**Subject: Third-Party Review of Streamflow Assessment Report prepared for 19618 SE Bornstedt Road, Sandy, Oregon PHS #74178**

### Bornstedt View Subdivision 21-021 SandyNet Comments

Re: Bornstedt Views Subdivision File No. 21-021 SUB/TREE

DATE: June 14, 2022  
REQUEST: Bornstedt Views Transportation Review  
FILE NO: 21-021 SUB/VAR/TREE/HD  
REVIEWER: Carl Springer, PE, DKS Associates

**Figure**

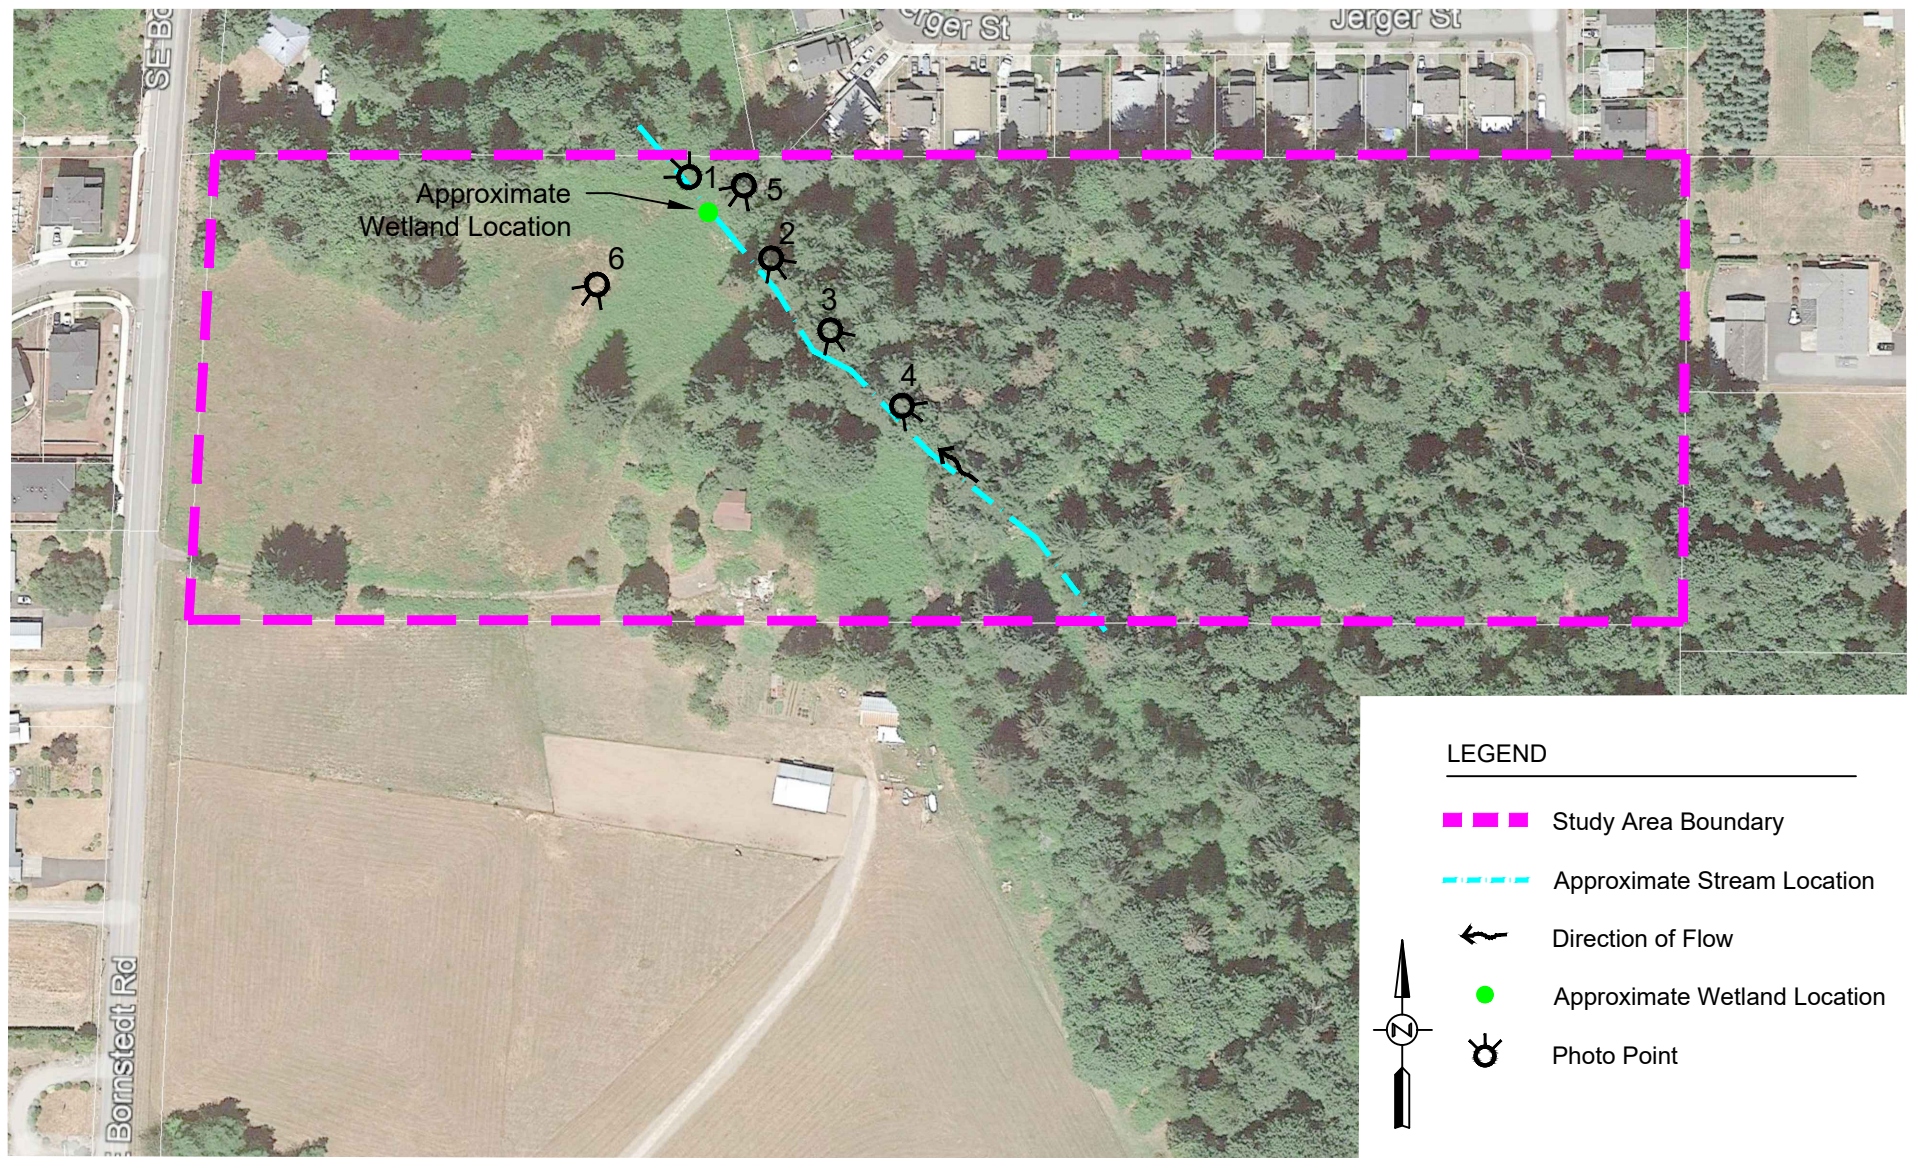
Photos of existing conditions at the time of PHS’s site visit are included in Attachment A. A figure showing the location of the photos and the approximate location of wetland, and the mapped stream

Based on the presence of wetland plants with a FACW indicator status in portions of the stream channel and the presence of soils meeting hydric soil indicators within the drainageway, it is PHS's opinion that the stream may be intermittent rather than ephemeral. By definition, ephemeral streams flow only in direct response to precipitation. The streambed is always above the water table, and stormwater runoff is the primary source of water. Intermittent streams contain water for only part of the year, typically during the winter and spring when the streambed is below the water table and/or snowmelt from surrounding uplands provides sustained flow. Because the original streamflow assessment was conducted in September 2021 (a time of year when an intermittent stream might be expected to be dry) and because PHS's site visit was conducted during winter after a period of higher-than-average precipitation (a time of year when it can be extremely difficult to distinguish between intermittent and ephemeral streams), PHS recommends that the stream be observed and reassessed during the late spring after a precipitation event and again after a period with no precipitation to determine if flow persists and if stream flows are truly ephemeral rather than intermittent.

Additionally, NWI mapping depicts wetland on the site, and PHS's observation of hydric soils within a hydrophytic plant community indicate that wetlands subject to jurisdiction under the Oregon Removal-Fill Law and/or Section 404 of the Clean Water Act may be present on the site. A wetland delineation of wetlands is recommended to document the location and extent of wetlands on the site.
